Westinghouse  
Electric Corporation

NTD-NRC-94-4276  
DCP/NRC0195  
Docket No.: STN-52-003

SUBJECT: WESTINGHOUSE RESPONSES TO NRC REQUESTS FOR ADDITIONAL  
INFORMATION ON THE AP600

NTD-NRC-94-4276  
ATTACHMENT A  
AP600 RAI RESPONSES  
SUBMITTED AUGUST 26, 1994

Figure 231.29-1  
2D SASSI Analysis, N-S Direction  
Poisson Ratio Evaluation

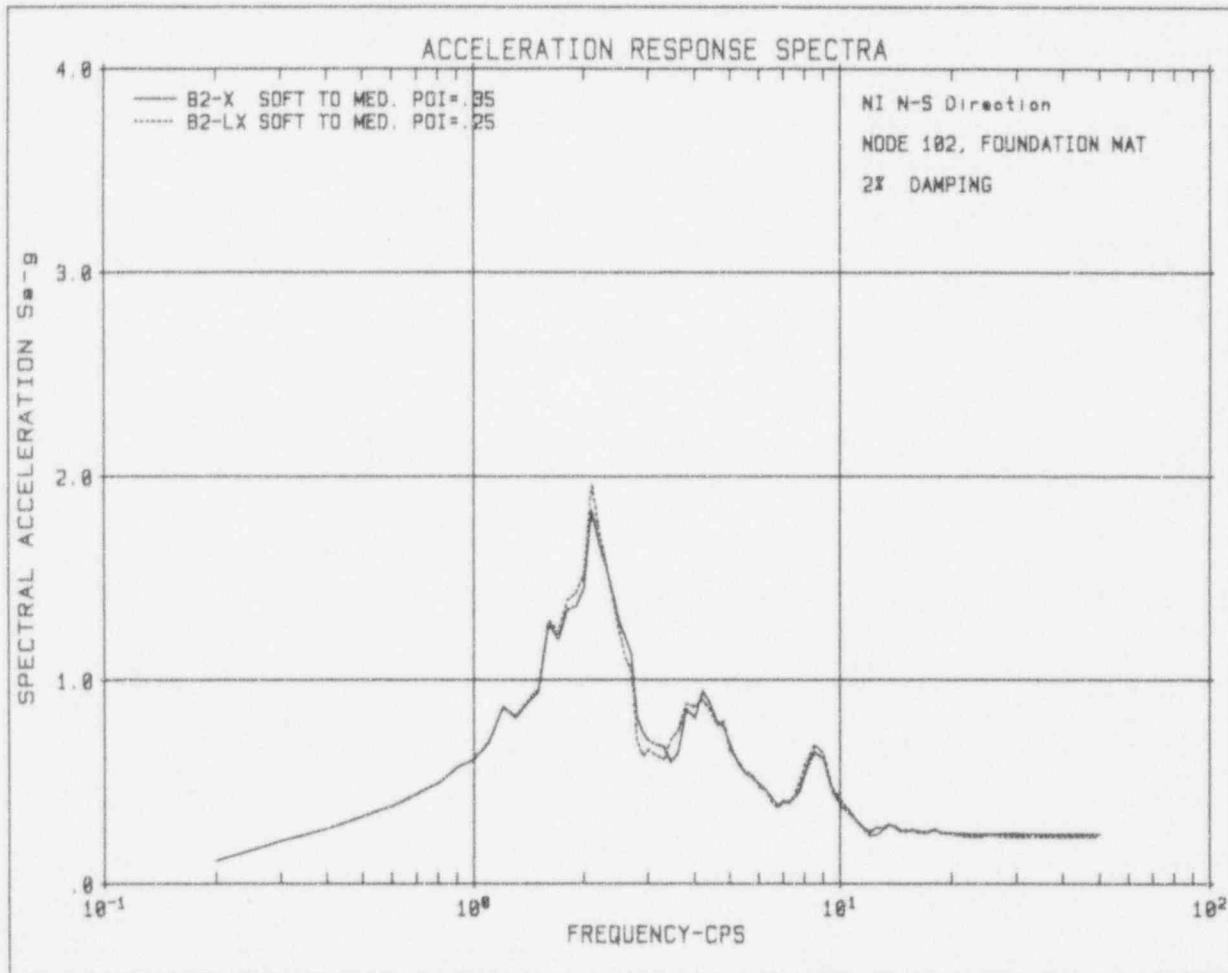
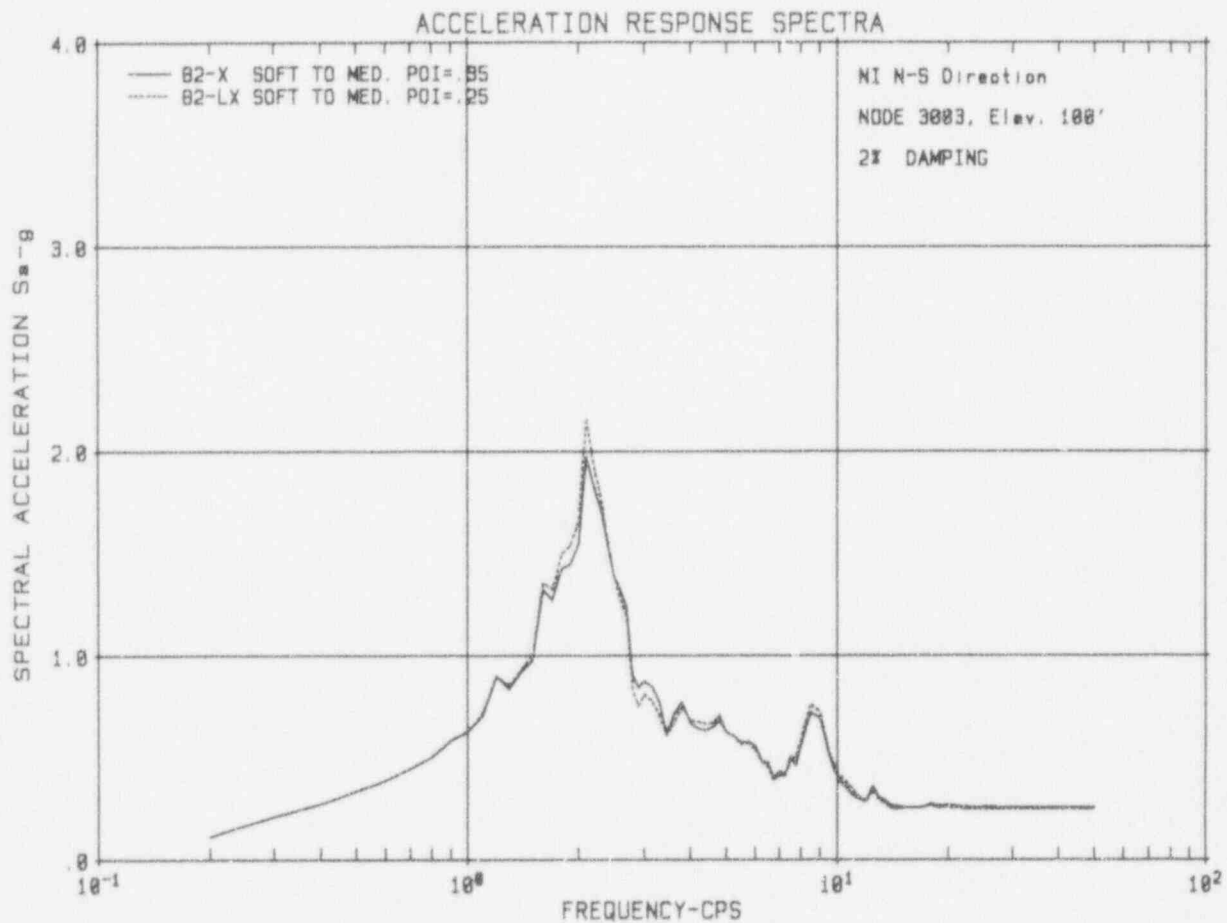
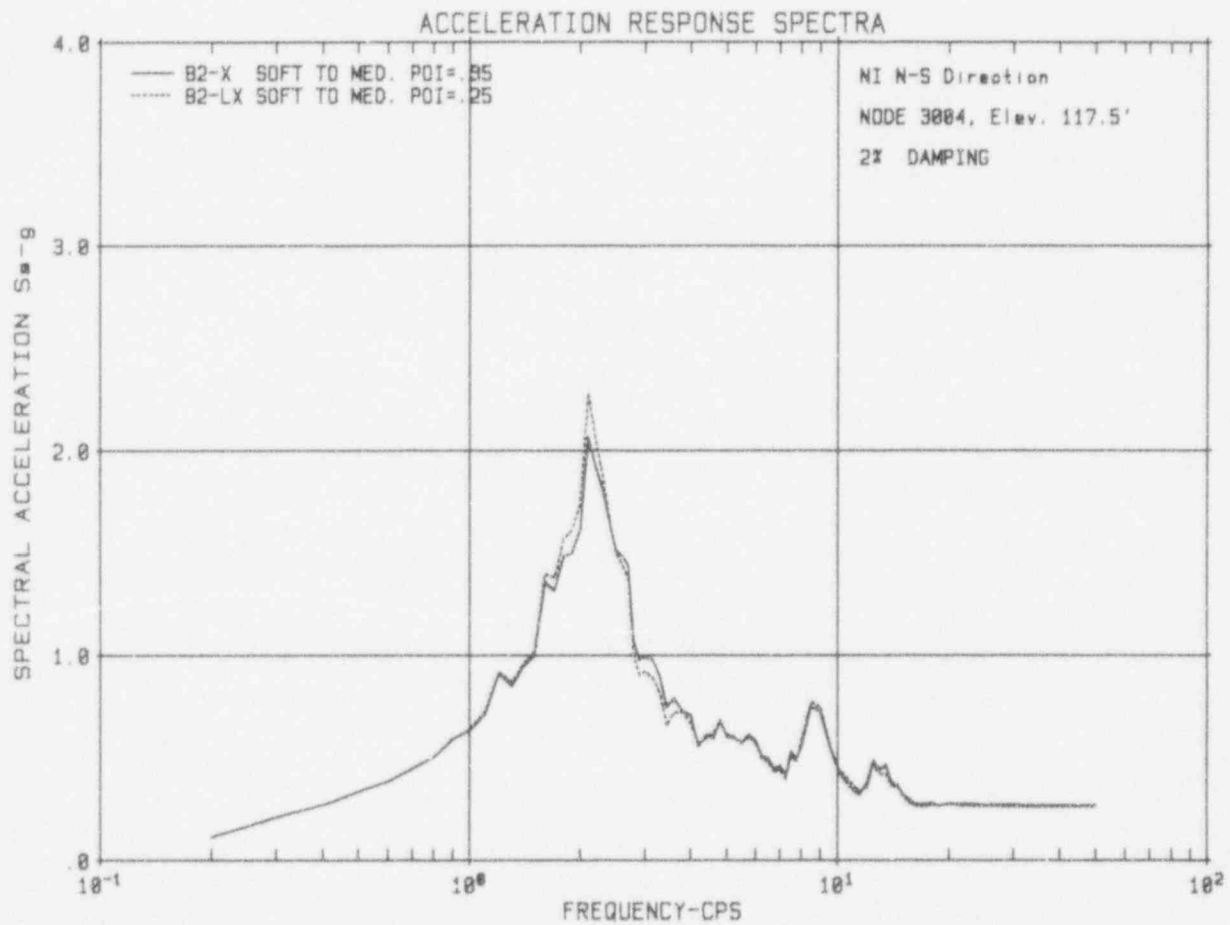
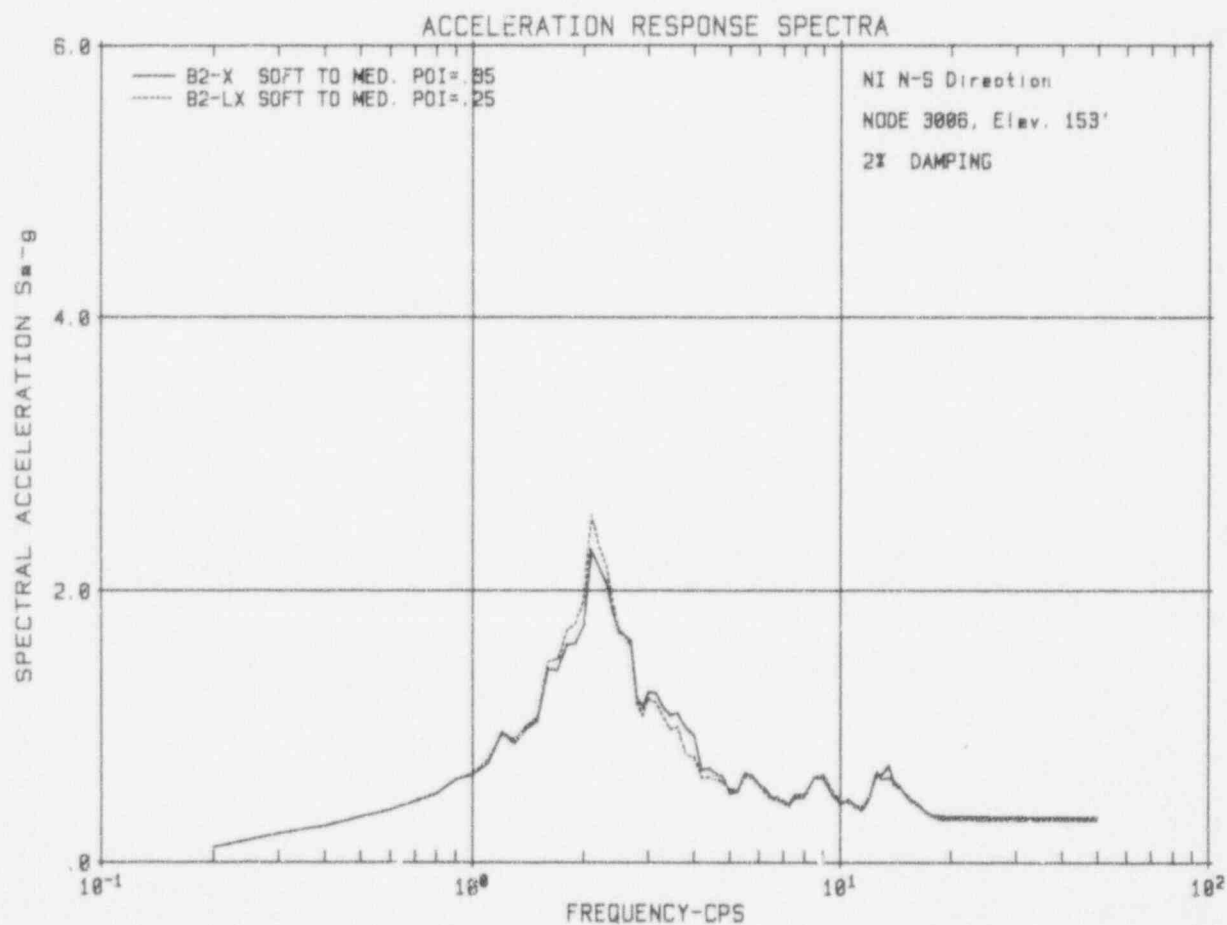
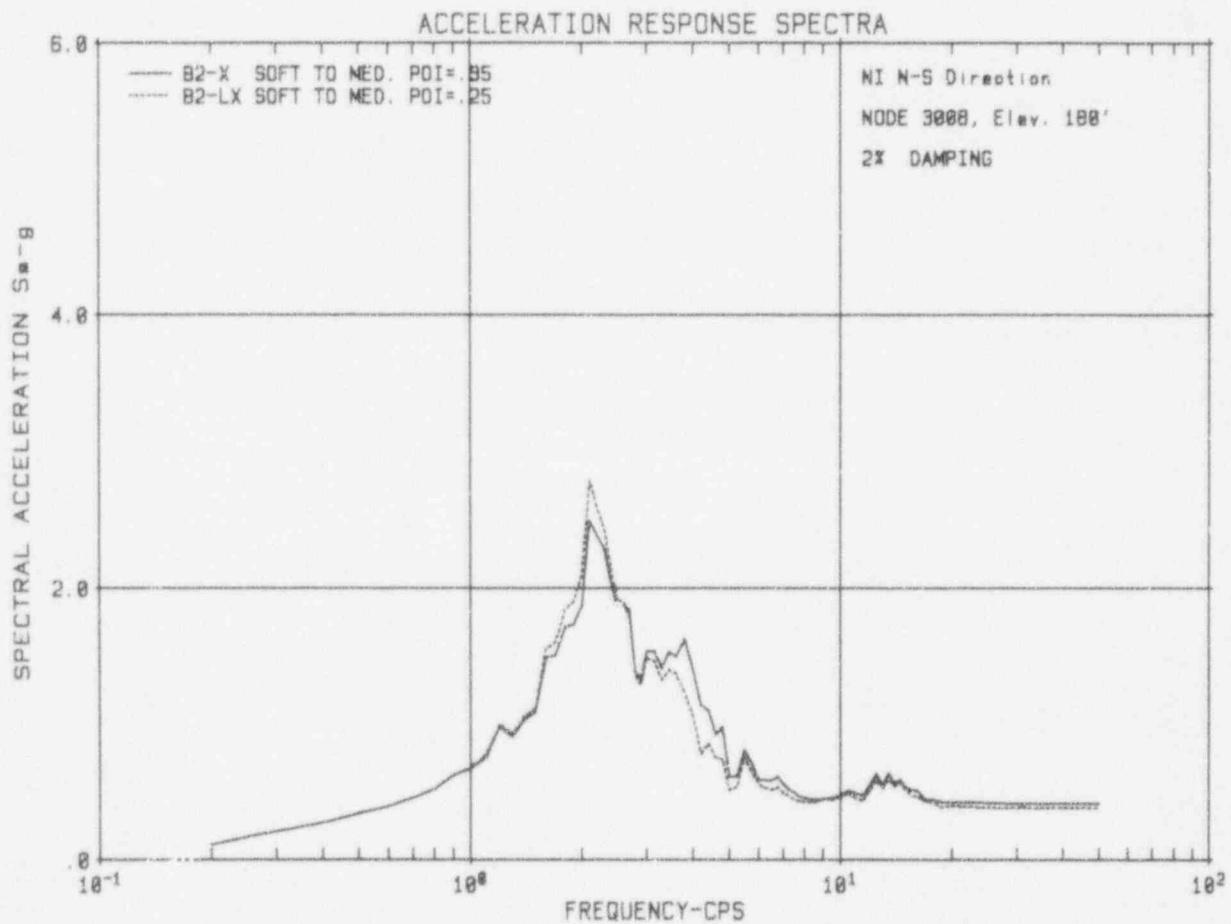
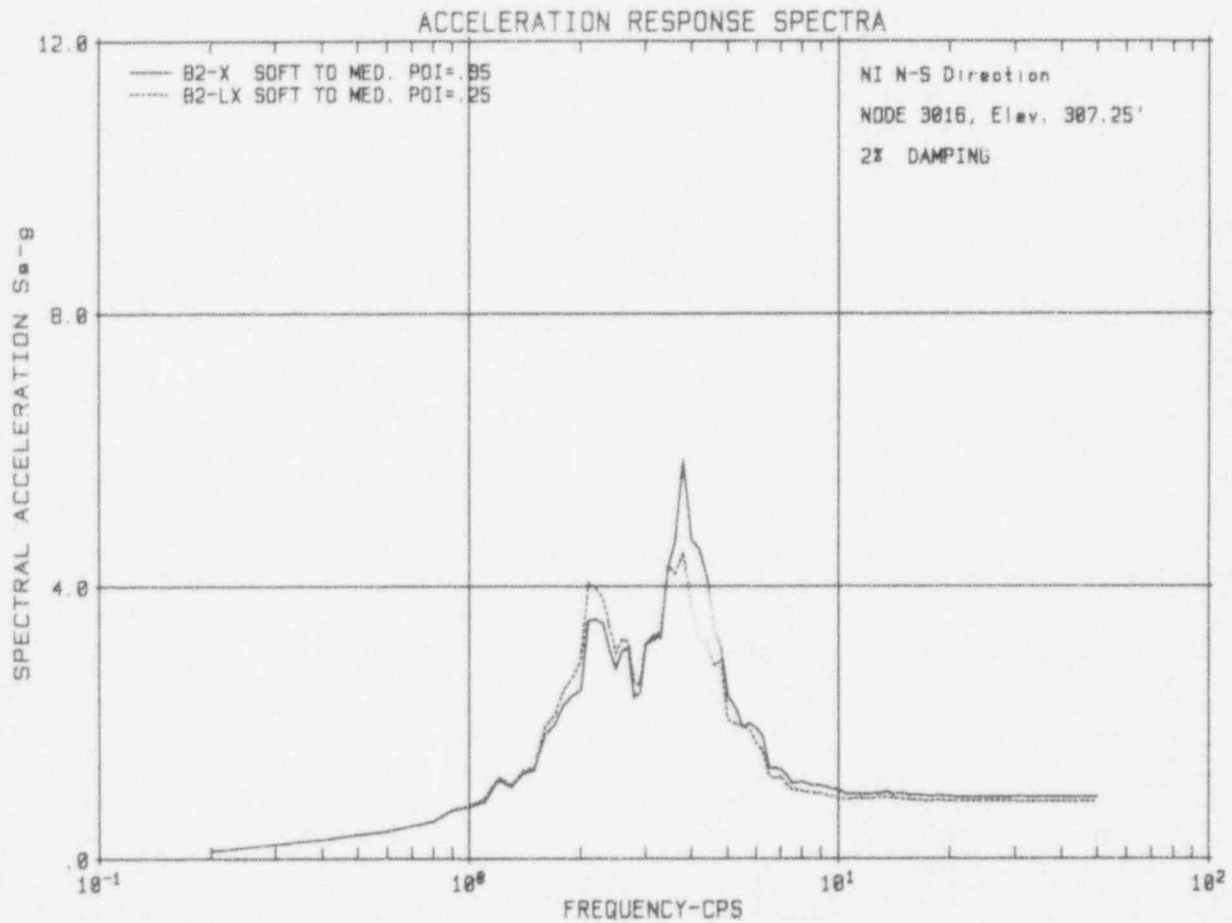
#### Question 231.29

The case of soft-to-medium soil profile with the water table and base rock at 120 ft depth was analyzed using the 2D SSI model of the nuclear island in the NS direction. For this soil profile, a constant Poisson's ratio of 0.25 was used for all soil layers. The results of the SSI analysis for this case were compared with the results of the same soil case with the previously used Poisson's ratio of 0.35 in Figures 231.29-1 through 231.29-11. As shown in these figures, the effect of change in the Poisson's ratio on the SSI responses is relatively insignificant. It should be also noted that the design soil profiles which were identified from a series of 2D SSI analysis cases in the SSAR define the water table at grade level for all soil cases. For these profiles, the Poisson's ratios were adjusted to maintain the P-wave velocity of water.

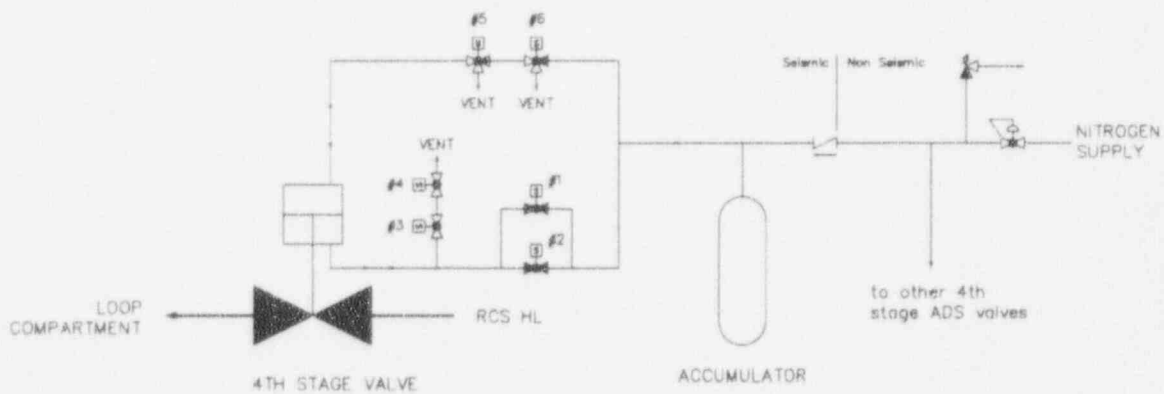
- b. Include these backup safety-related accumulators in a non-proprietary figure.
- c. Revise the SSAR to include information about (1) leak testing the accumulators, (2) seismic qualification of the accumulators, (3) the ability of the accumulators to open the valves against maximum containment pressure, (4) the capacity of the accumulators, and (5) testing of the accumulators in accordance to RG 1.68.3.

- b) The AP600 design change report transmitted to the NRC on February 15 1994 indicates that piston operated gate valves are one of the valve types being considered for the automatic depressurization system stage four valves. In the event that a piston operated gate valve is used, a backup safety-related N<sub>2</sub> accumulator configuration would be provided as shown in the attached sketch.
